# PRELIMINARY AND FINAL LAND DEVELOPMENT PLANS FOR **BUTLER AVENUE PROPERTY** T.P. # 26-005-023 **409 WEST BUTLER AVENUE** NEW BRITAIN TOWNSHIP, BUCKS COUNTY, PA

January 19, 2022

File No. 19-04109

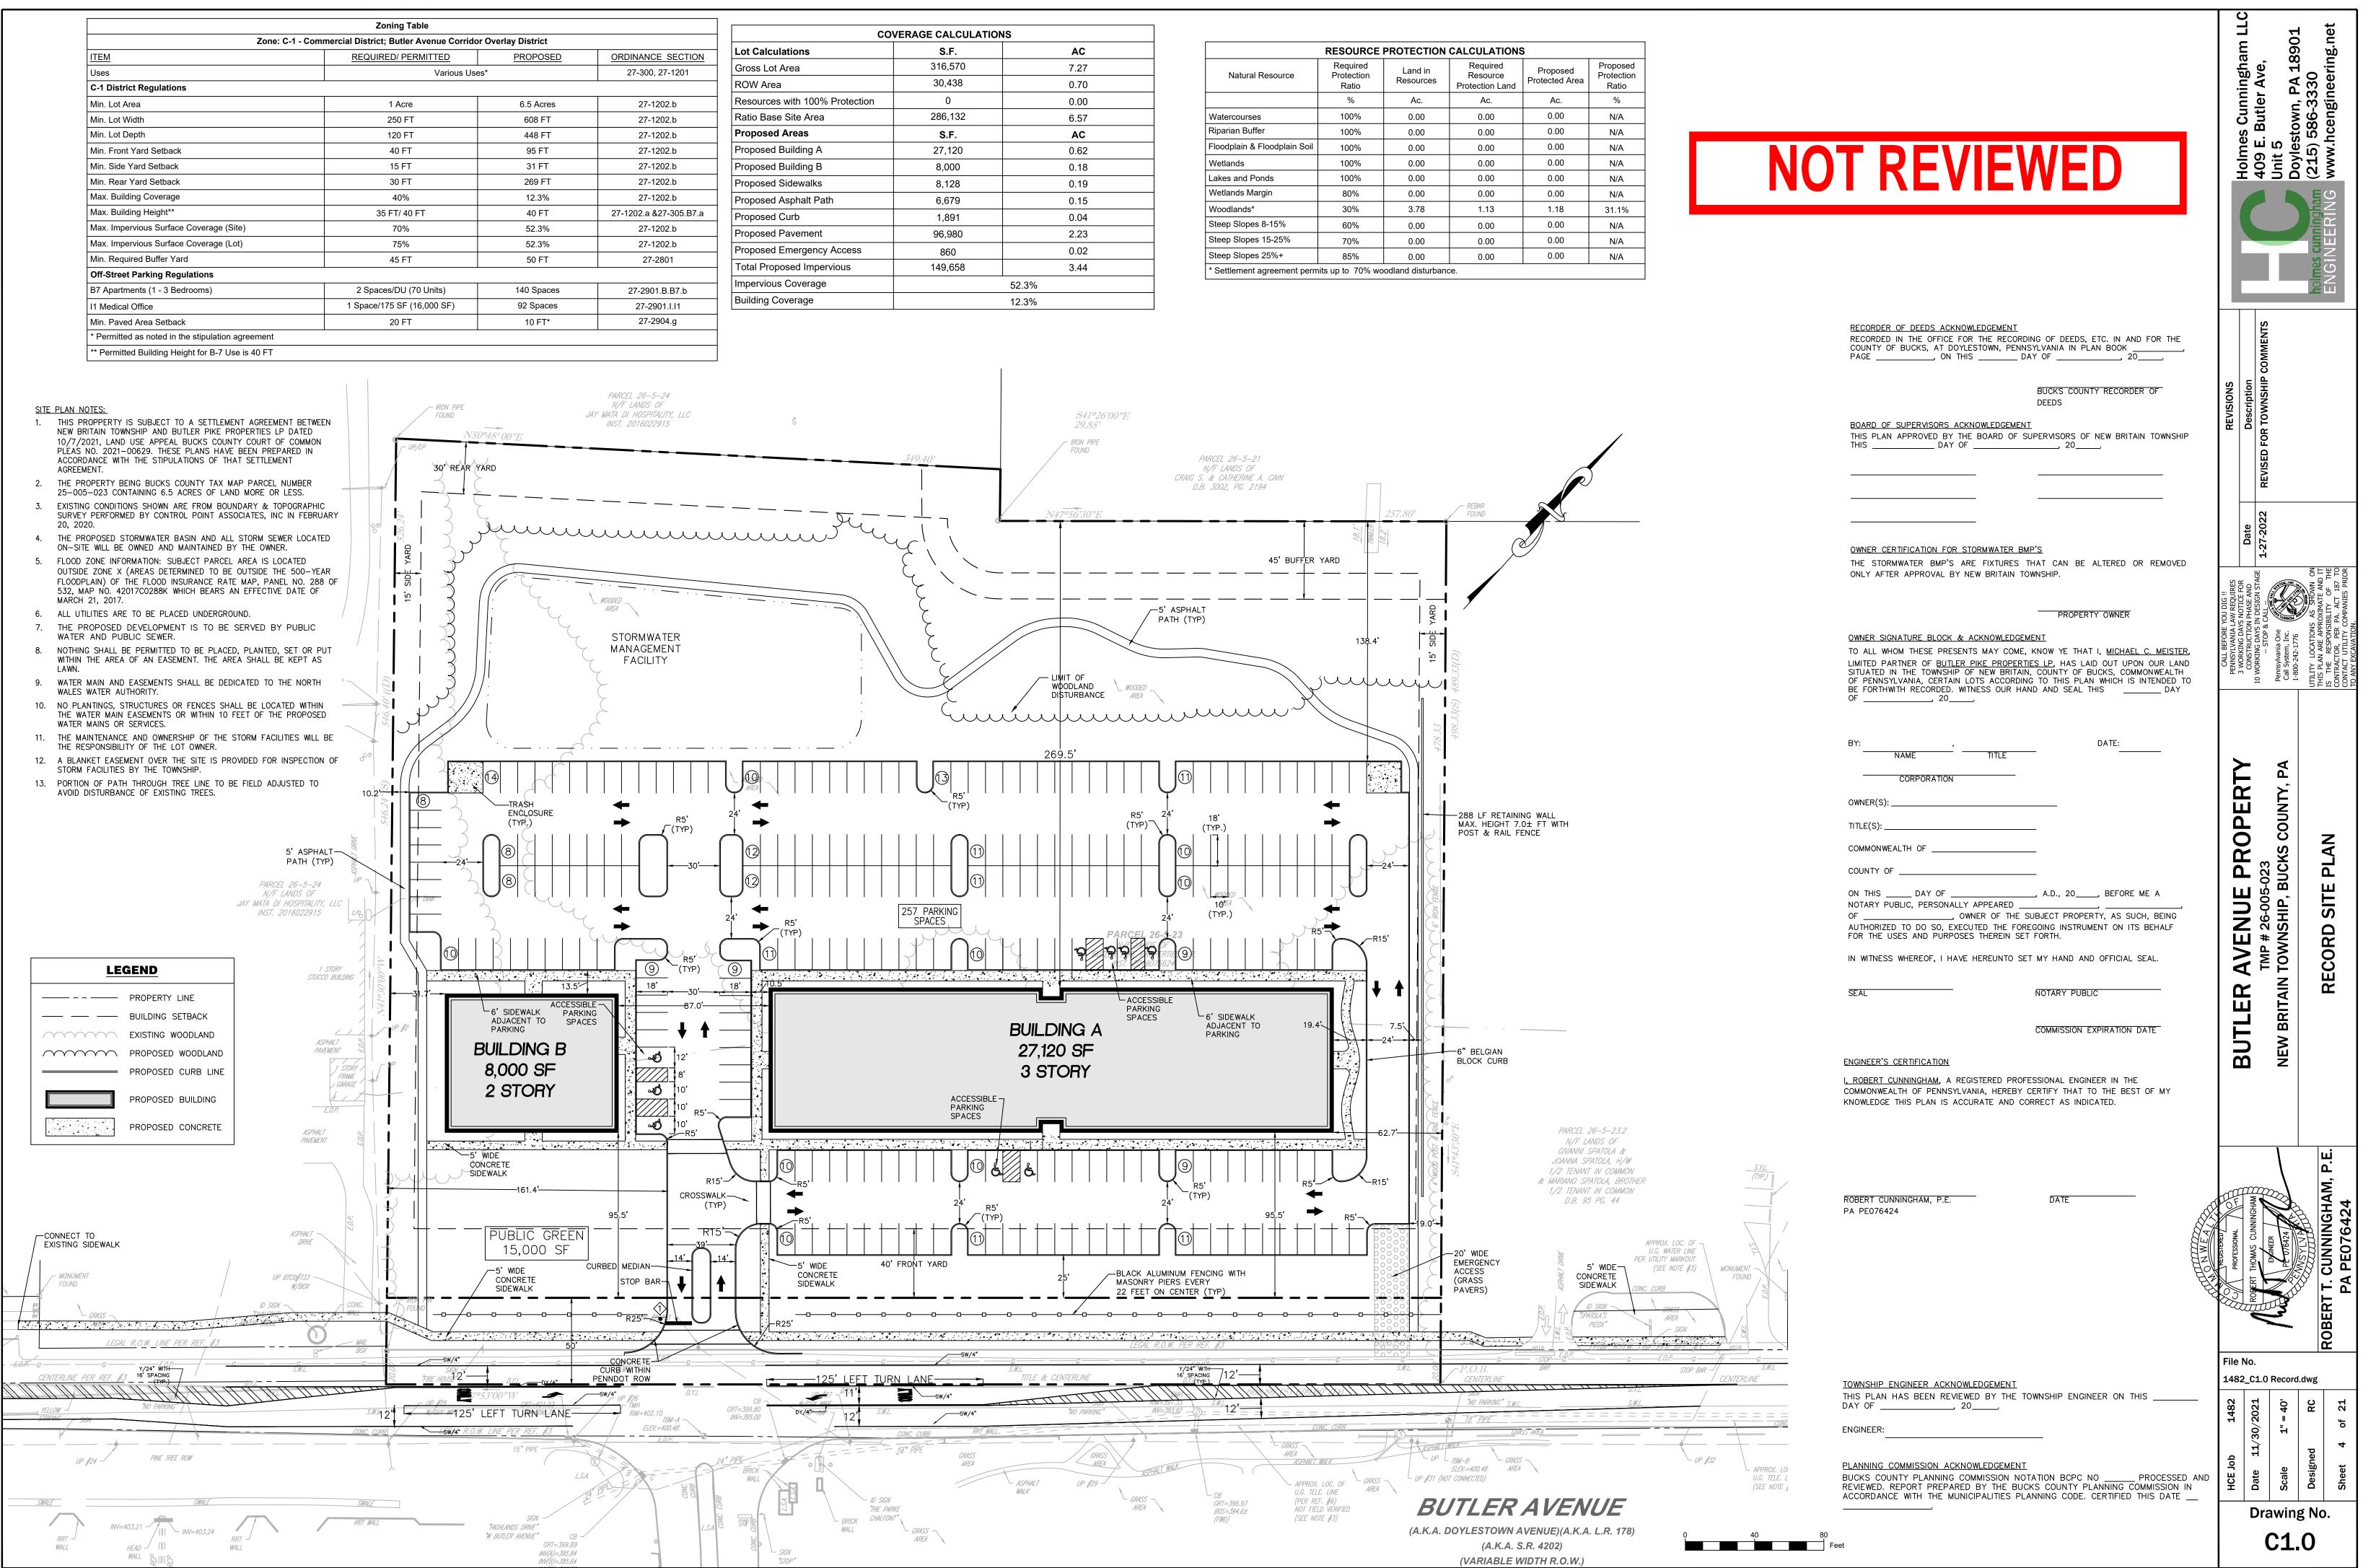
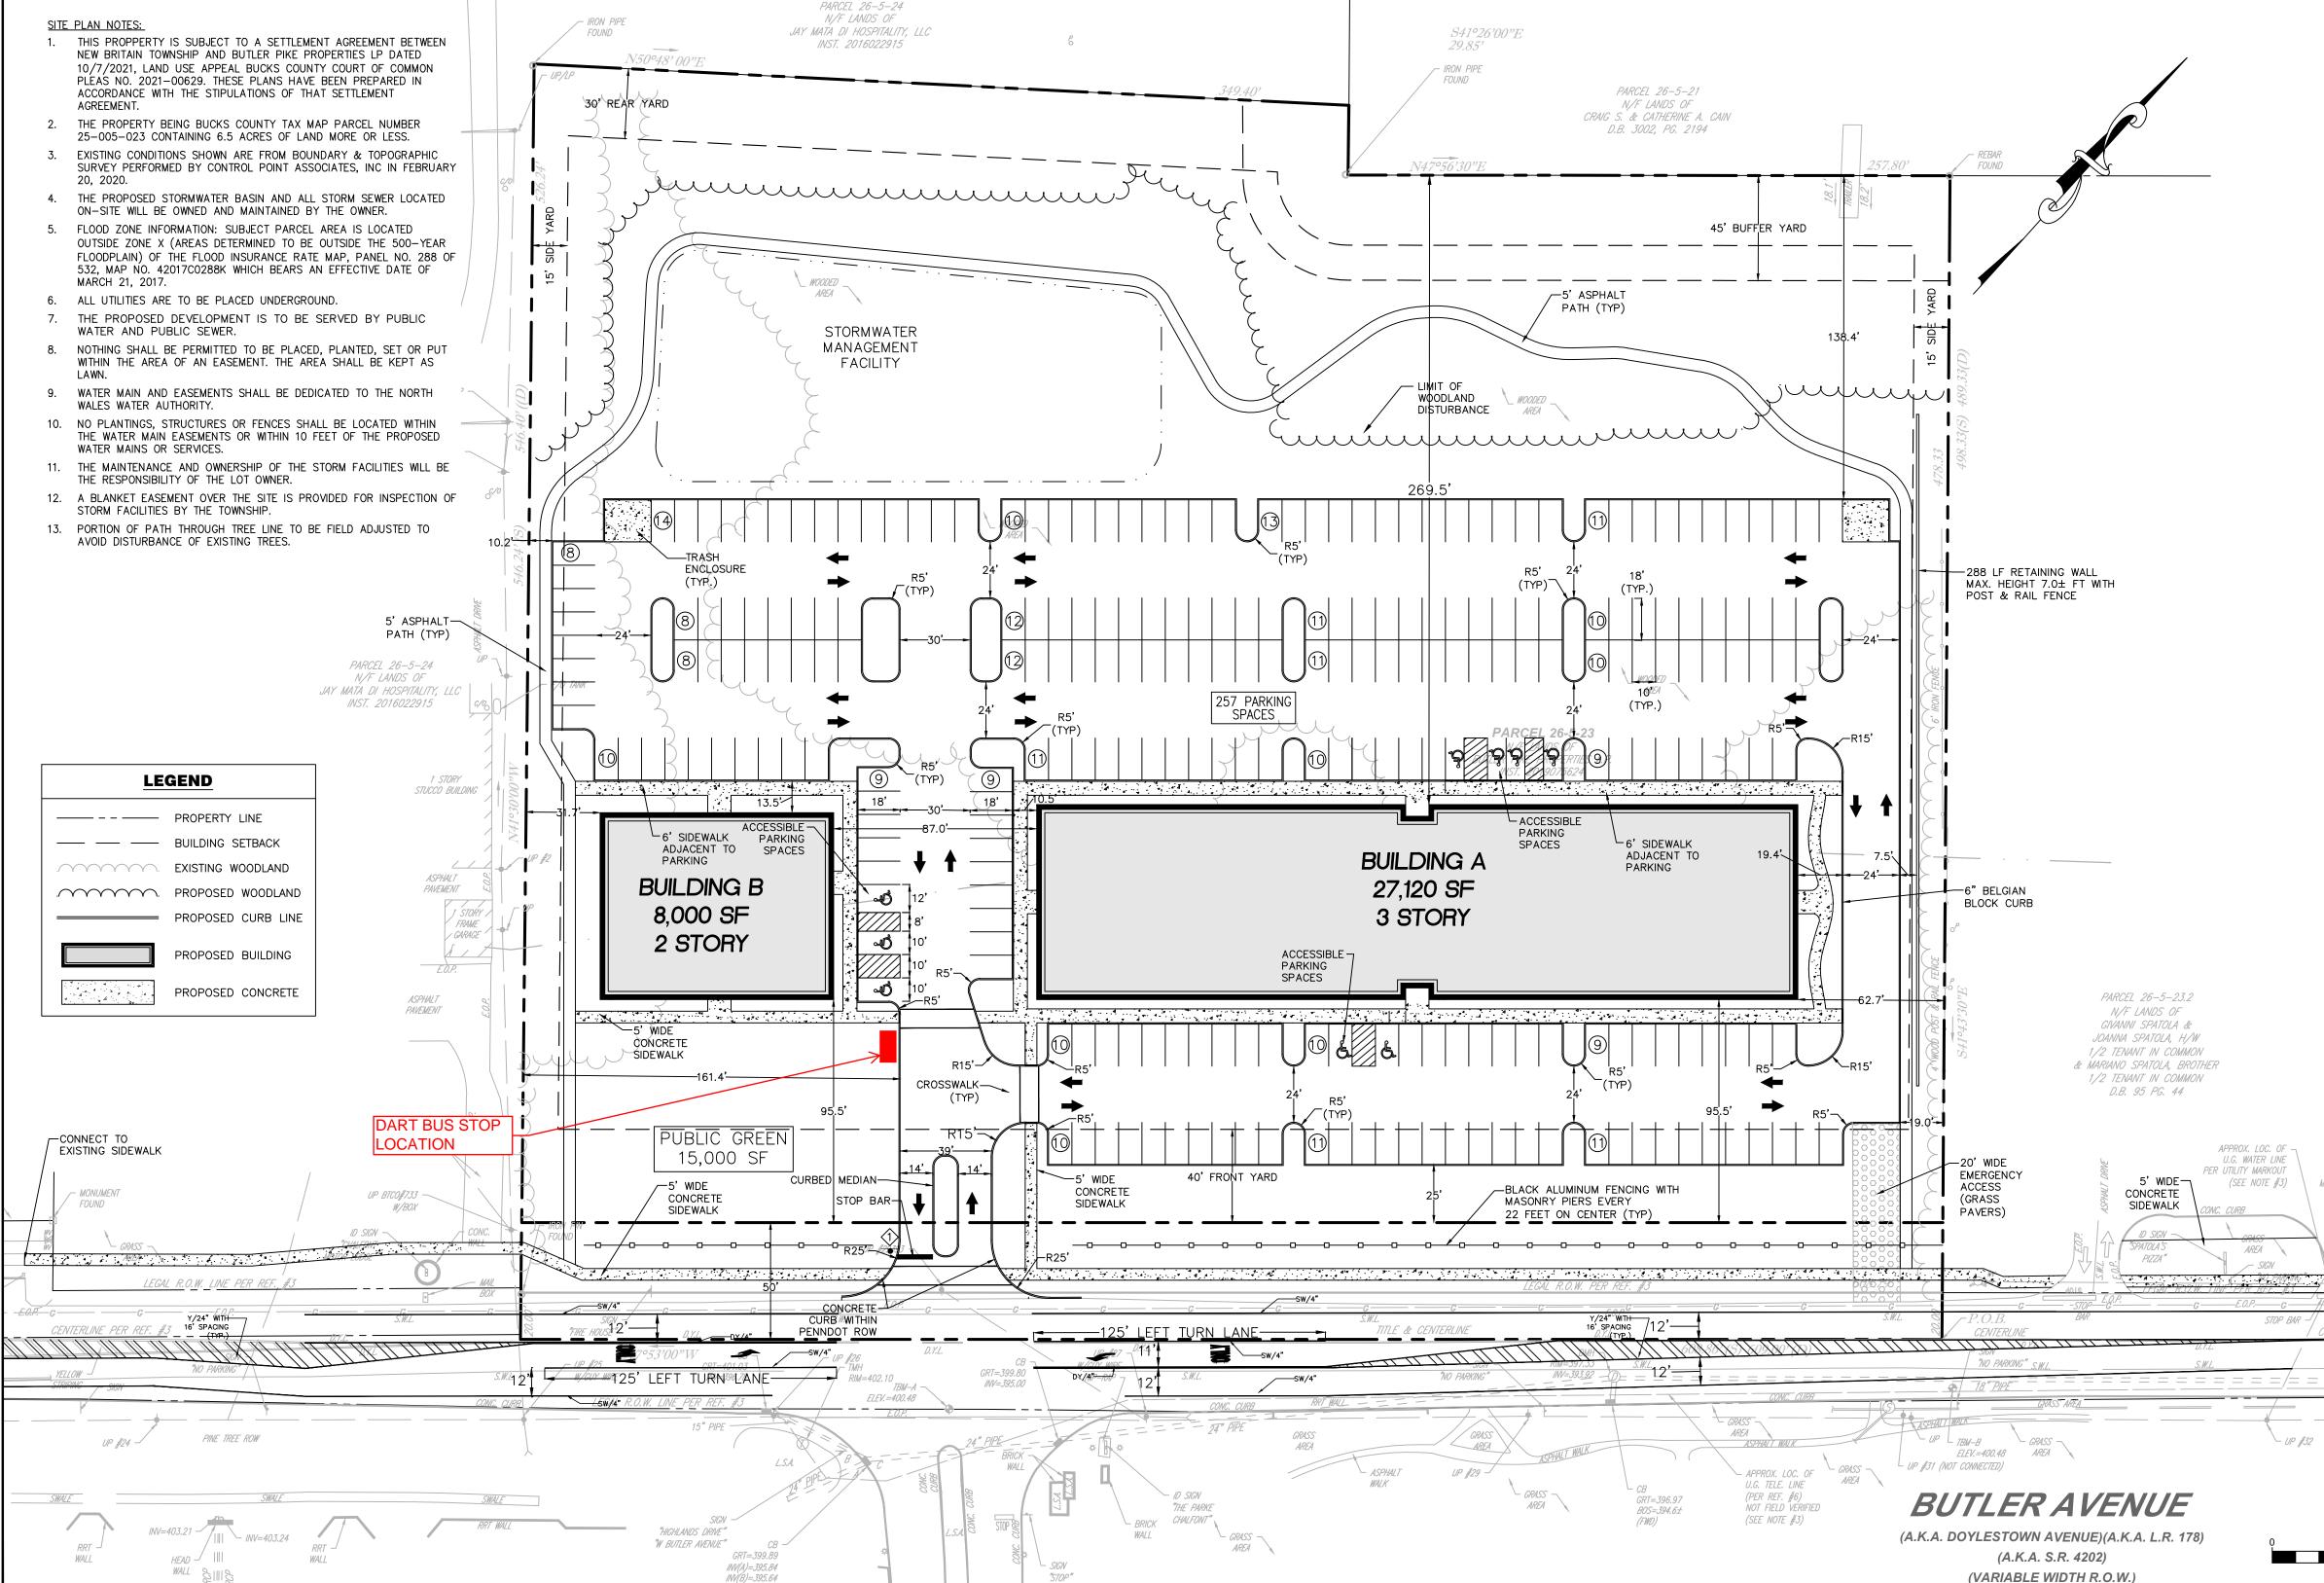
- <u>§27-201</u> The ratio base site area is the area definition used to calculate the impervious and building areas for the site. It shall be clarified that the coverage calculations on Sheet 4 of 21 utilize the Ratio Base Site Area.

- 2. <u>§27-1202.a</u> No use in the C-1 Commercial District shall exceed 35 feet in height, however, apartment buildings, Use B7, are permitted to be 40 feet. The proposed building heights and maximum permitted height shall be noted on the Record Plan, Sheet 4.

- <u>§27-1202.b</u> The front, side and rear yard setback lines shall be dimensioned and labeled on the Record Plan, Sheet 4. We note that apartment buildings have separate setback requirements for the B7 Use.

1. <u>§27-201</u> – The ratio base site area is the area definition used to calculate the impervious and building areas for the site. It shall be clarified that the coverage calculations on Sheet 4 of 21 utilize the Ratio Base Site Area.

2. <u>§27-1202.a</u> – No use in the C-1 Commercial District shall exceed 35 feet in height, however, apartment buildings, Use B7, are permitted to be 40 feet. The proposed building heights and maximum permitted height shall be noted on the Record Plan, Sheet 4. **Response: Will Comply. The notes will be added to the plan.**

3. <u>§27-1202.b</u> – The front, side and rear yard setback lines shall be dimensioned and labeled on the Record Plan, Sheet 4. We note that apartment buildings have separate setback requirements for the B7 Use.
